GENERAL PROJECT REPORT
WESTERN DISTRIBUTING

ADMINISTRATIVE REVIEW

FILE: #220-94

REQUEST: New construction of a 7,680-square-foot shipping and receiving warehouse

93 SCALE: 3/4" = 1'-0"

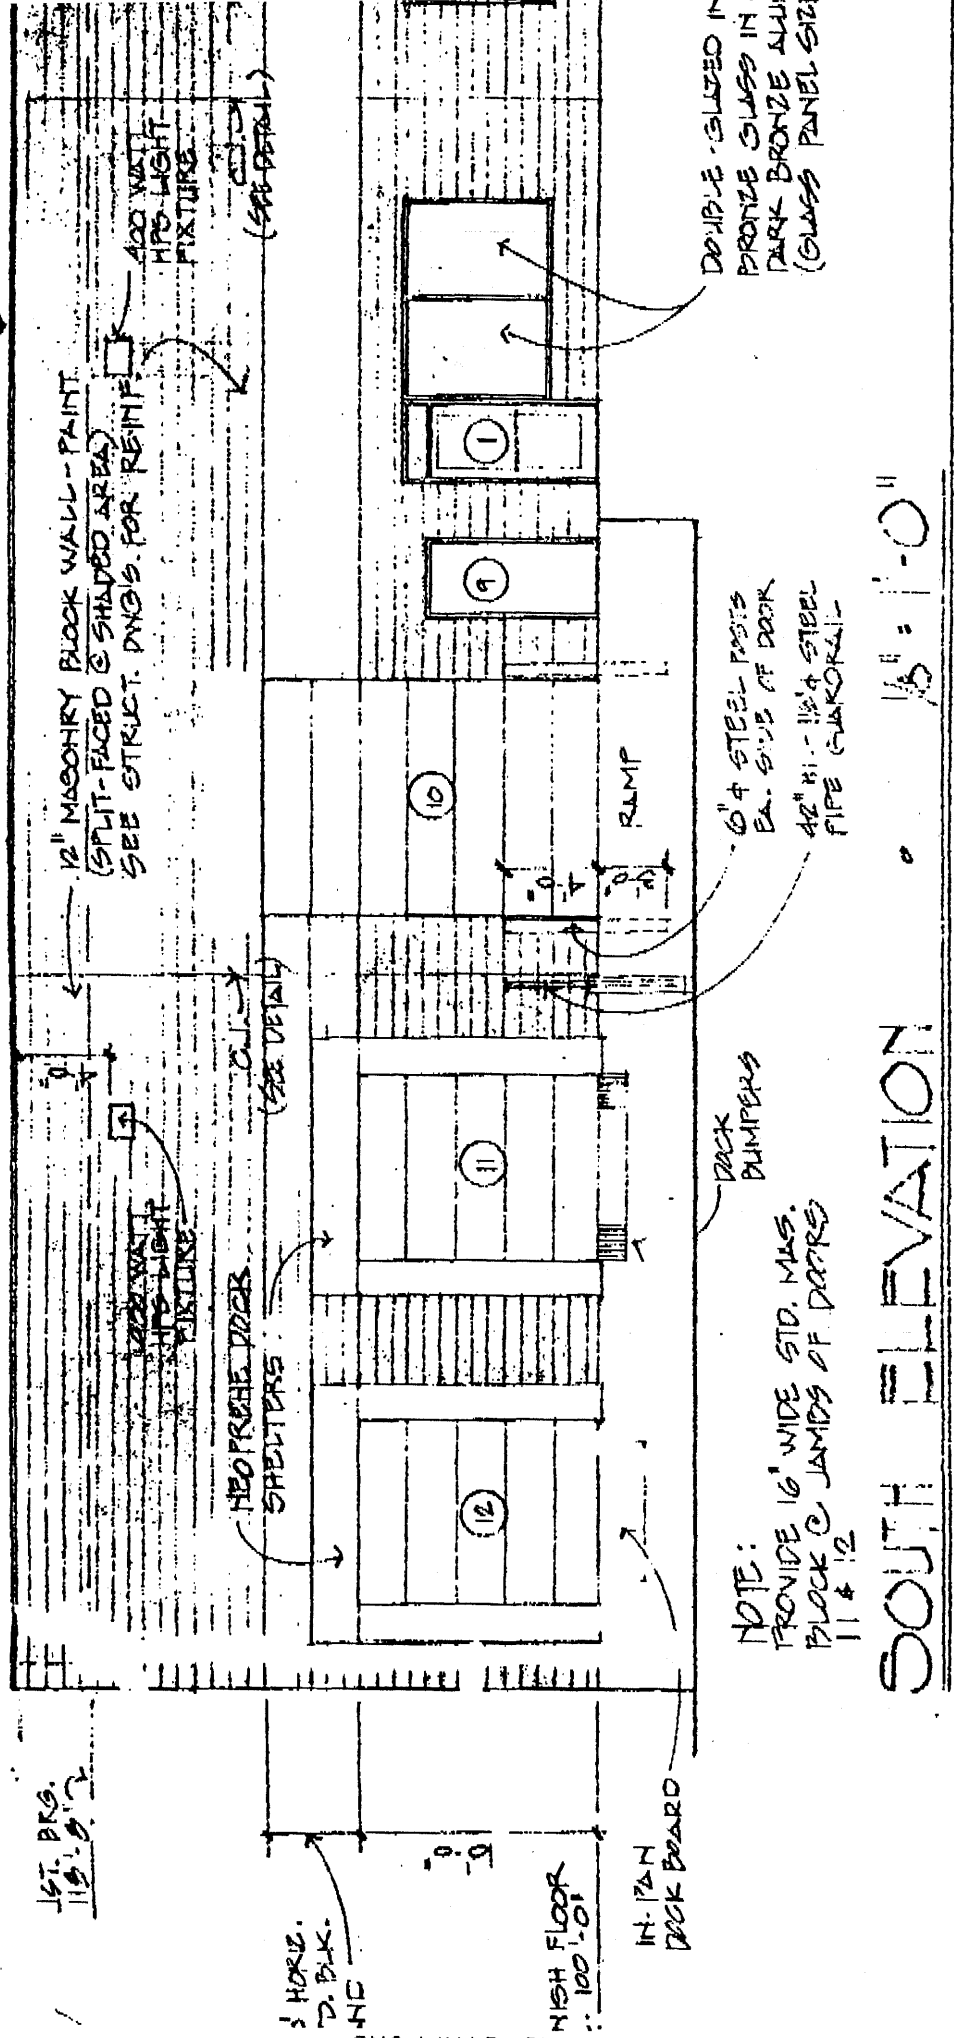
- 1) A drainage fee of \$3,108.00 is payable prior to planning clearance.
- 2) A Transportation Capacity Payment of \$1,873.90 is payable prior to planning clearance.
- 3) A sidewalk shall be constructed along the entire site frontage in association with a building permit for the warehouse building.
- 4) A building detail of the proposed retaining wall shall be provided for review by the City Development Engineer.

I have also addressed items 3 & 4 of the Administrative Review by including copies of the Improvements Agreement guaranteeing construction of the sidewalk, and the detail of the proposed retaining wall.

NOTE: TOP OF WALL & FOOTING STEP PER GRADES OF CIVIL DRAWING
